#### **ENGINEERING CHANGE NOTICE** DART AEROSPACE LTD

# DART SERVICE INSTRUCTION

TO AMEND DRAWING D350-591 REV. F REF. CANADIAN STC: SH92-6 FAA STC: SH967NE

## FIGURE 1 - CLAMP/CUSHION INSTALLATION

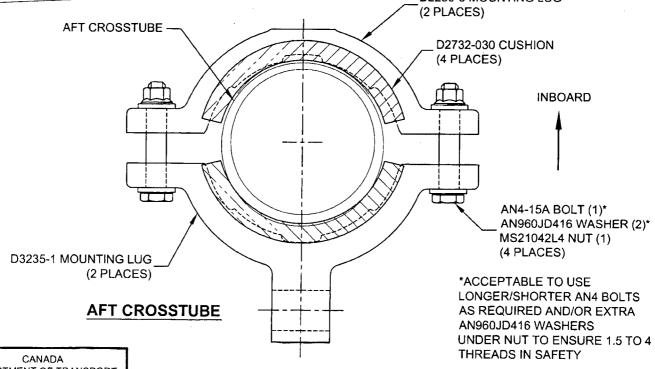
TO IMPROVE THE FIT OF THE D350-591-311/-312 STEPS, IT IS ACCEPTABLE TO INSTALL THE DSI 9410-011 KIT. INSTALL THE D2732-030 CUSHION (AFT CROSSTUBE ) AND D3595-200-300 CUSHION (FWD CROSSTUBE) AS SHOWN IN FIGURE 1 IN PLACE OF THE D2856-400-720 ABRASION STRIP CALLED OUT ON DRAWING D350-591 REV. F.

FOR CUSTOMERS WHO HAVE PREVIOUSLY INSTALLED D2856-400-720 ABRASION STRIPS REMOVE THE ABRASION STRIPS IN ACCORDANCE WITH ICA-D350-591.

PRIOR TO INSTALLING THE DSI 9410-011 KIT.
